SEABROOK STATION
Engineering Office:
1671 Worcester Road
Framingham, Massachusetts 01701
(617)-872-8100

April 15, 1986
SBN- 1004
T.F. B7.1.2

Subject: Level Measurement Error (SER Outstanding Issue No. 10)

Revised Response to RAI 420.23

Figure 1 Schematic of Heat Transfer Model for Reference Leg Thermal Response

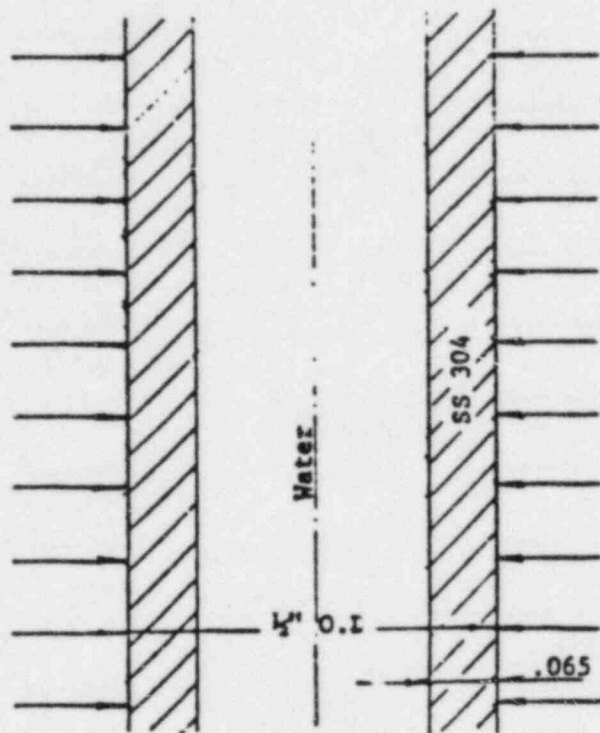
Describe how the effects of high temperatures in reference legs of steam generator and pressurizer water level measuring instruments subsequent to high energy breaks are evaluated and compensated for in determining setpoints. Identify and describe any modifications planned or taken in response to IEB 79-21. Also, describe the level measurement errors due to environmental temperature effects on other level instruments using reference legs.

- g. Containment free volume is $2.84 \times 10^6 \text{ ft}^3$ (approximately 5% higher than that used in the DBA analysis).
- h. The reference leg response is calculated following guidelines prescribed in NUREG-0588² using the HESITET³ computer program. Figure 1 is the schematic of the reference leg model.
